ADDENDUM NO.: TWO

DATE OF ADDENDUM: January 24, 2013

**Renovations & Additions to Jenkins-Waggoner Laboratory
CAES, 123 Huntington St, New Haven CT 06511
BI – P – 86**

Sketch Title: **PARTIAL - FRAME TYPES**
 Project Title: Renovations & Additions to Jenkins-Waggoner Laboratory
 Sketch Number: **ASK-A602a**
 RFI Number: .
 Reference Sheet: A-602

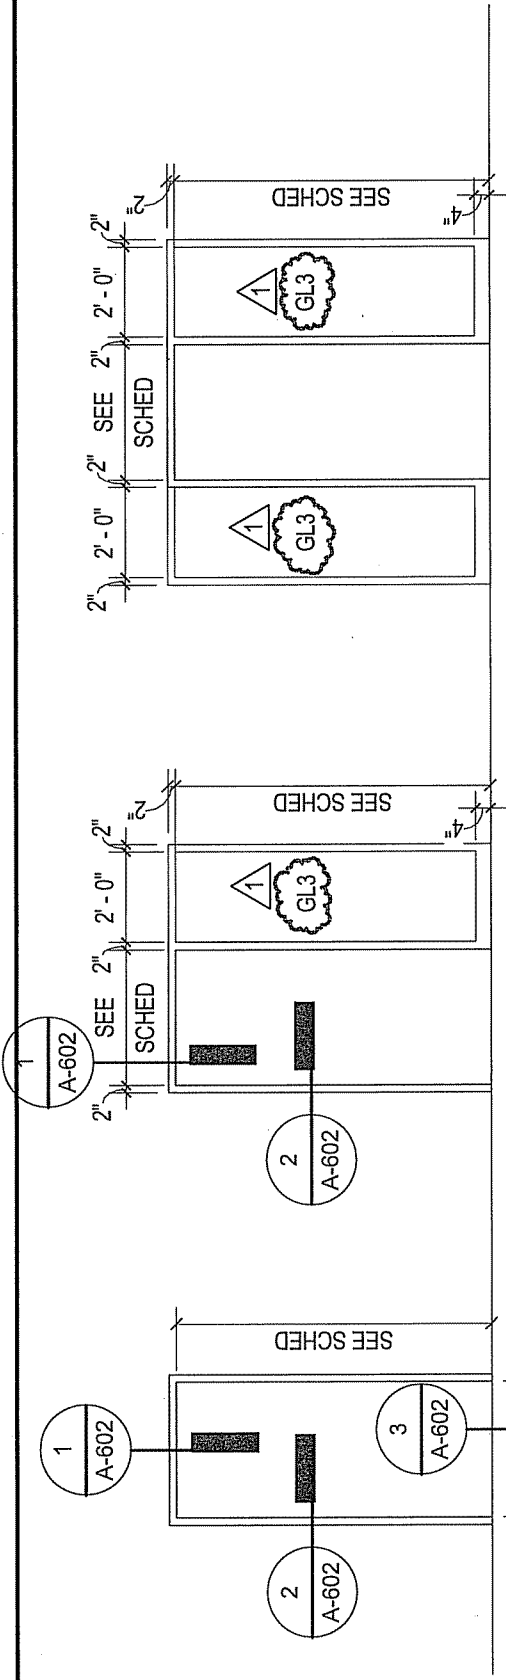
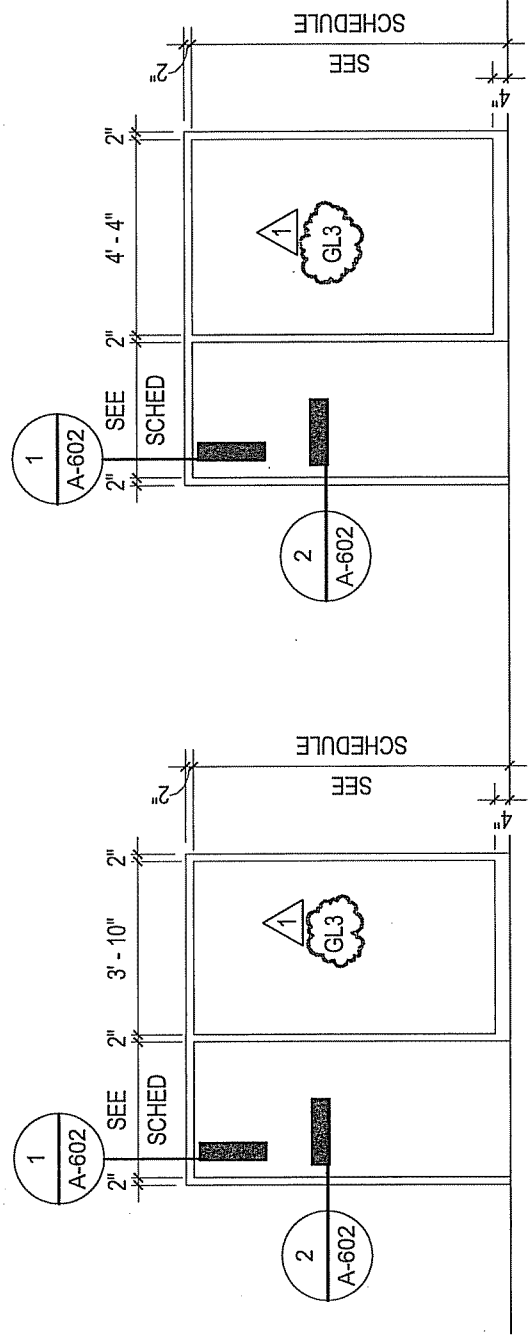
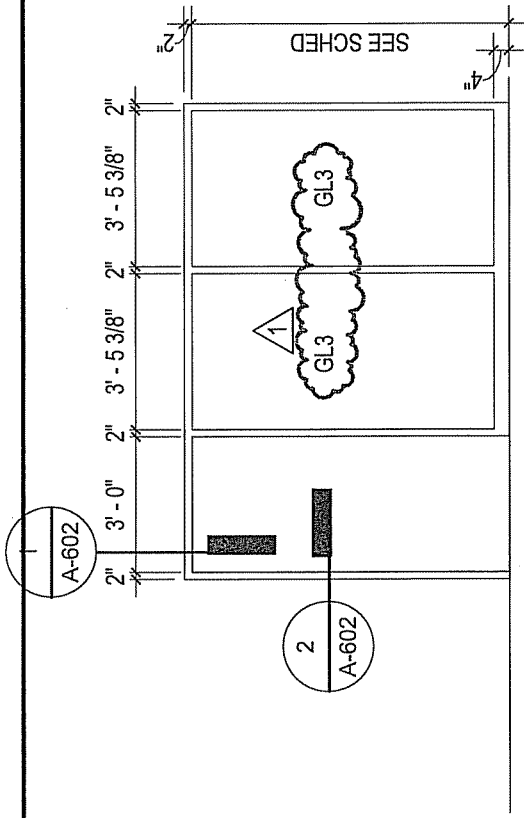
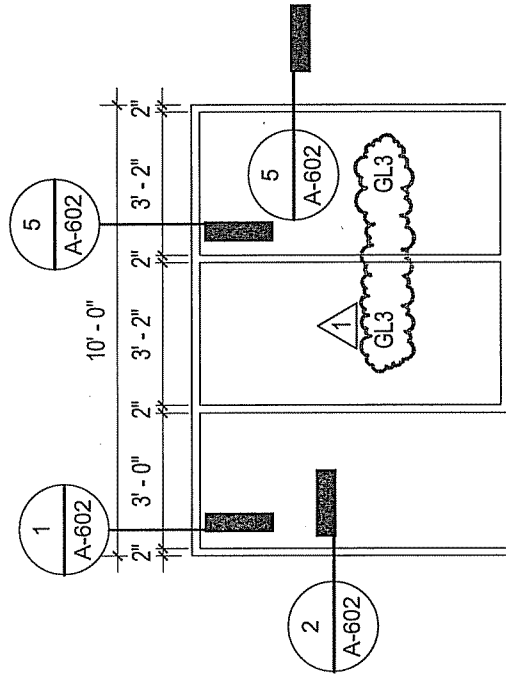
Drawing A-602. Frame Type clarifications. Refer to attached sketch ASK-A602b and ASK-A602c.

H.M. SILL @ WINDOW 000

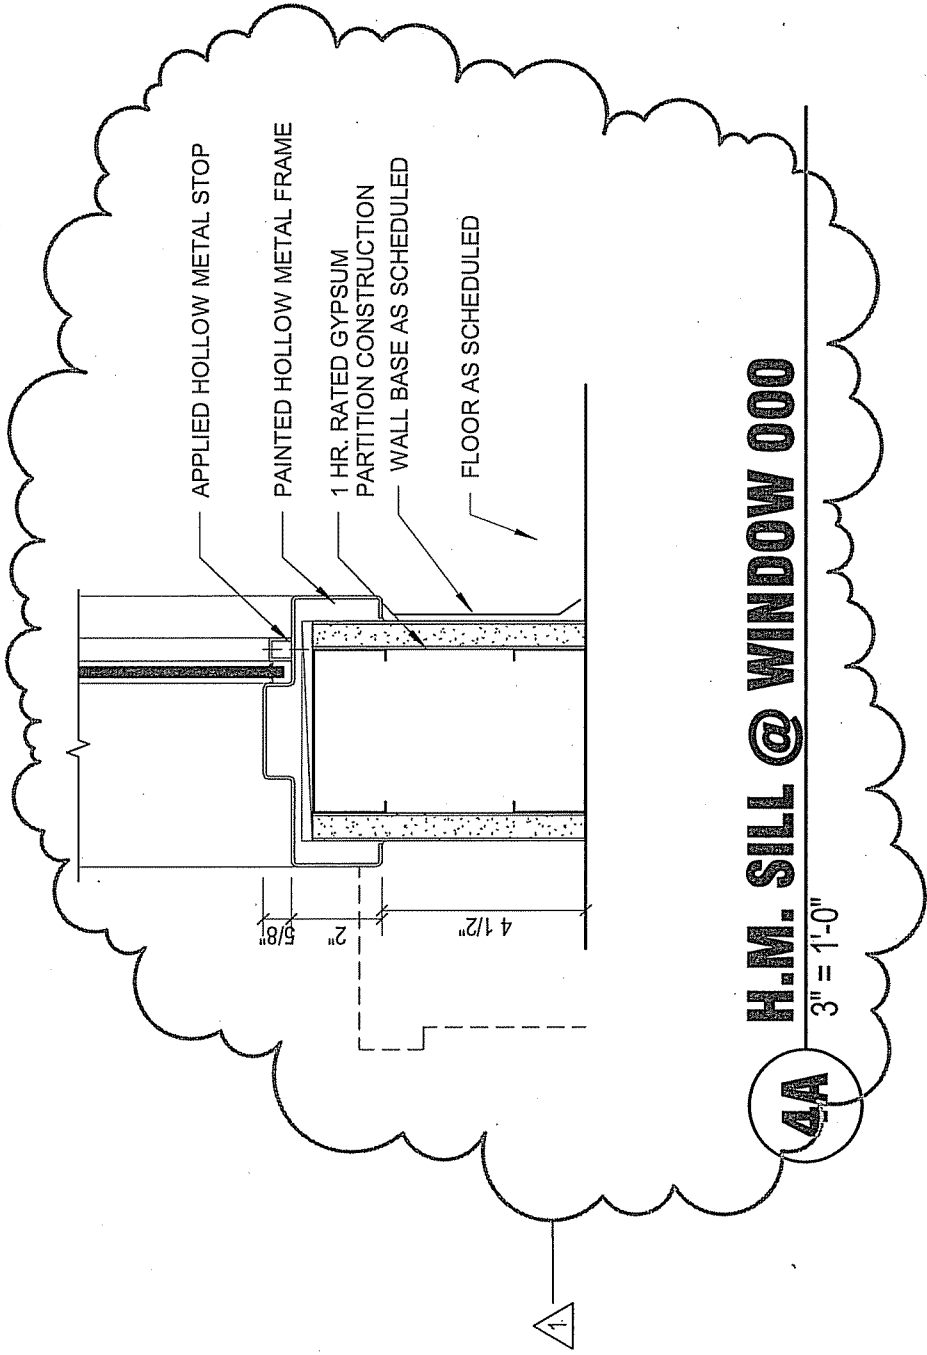
Drawing A-605. Interior Borrowed Light Schedule clarifications. Refer to attached sketch ASK-A605a and ASK-A605b.
